S.N.: 10/798,815
Art Unit: 2878

AMENDMENTS TO THE DRAWINGS:

REMARKS

FIG. 1A

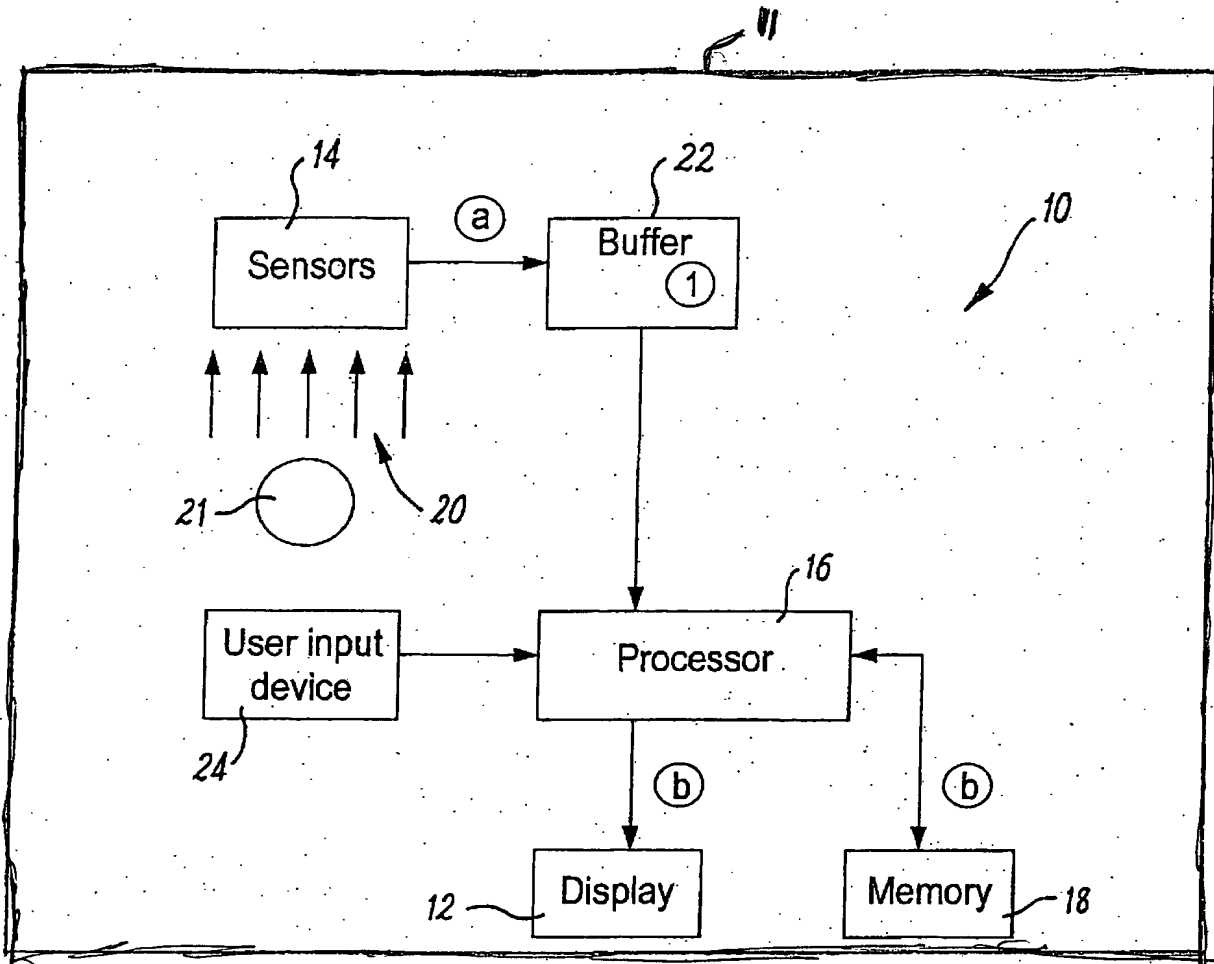
The attached sheet of drawings includes changes to Figs. 1A, 2A, and 3A, and replaces the original sheets of drawings corresponding to these figures. In Figs. 1A, 2A, and 3A, the previously omitted part number 11, referring to embodiments in which the systems 10 are incorporated into handheld devices 11, such as mobile phones, digital cameras, and PDAs, has been added.

The Patent Office objected to the drawings under 37 CFR 1.83(a). Replacement sheets are being provided in which system 10 is shown incorporated into a portable handheld device 11, which may be a digital camera, a mobile phone, or a PDA. Additionally, the specification, on page 5, lines 3-6, has been rearranged. It is respectfully submitted that no new matter has been added.

The Patent Office rejected claims 14, 15, and 25-27 under 35 U.S.C., 112, first paragraph, as failing to comply with the enablement requirement. By the replacement drawing sheets, Applicant shows that the systems of Figures 1A, 2A, and 3A are housed within a device 11 that may be a digital camera, a mobile phone, or a PDA. Presumably, one of ordinary skill would know how to modify a handheld device, such as a digital camera, a mobile phone, or a PDA, to include the system of the claimed invention. Figures 1A, 2A, and 3A show a processor that may be connected to other component parts associated with a camera or communications. The first paragraph of page 5 of Applicant's specification provides further enablement for these claims. It is respectfully submitted that claims 14, 15, and 25-27 are enabled by Applicant's disclosure and respectfully requested that the Patent Office withdraw its rejection of these claims under 35 U.S.C. 112, first paragraph.
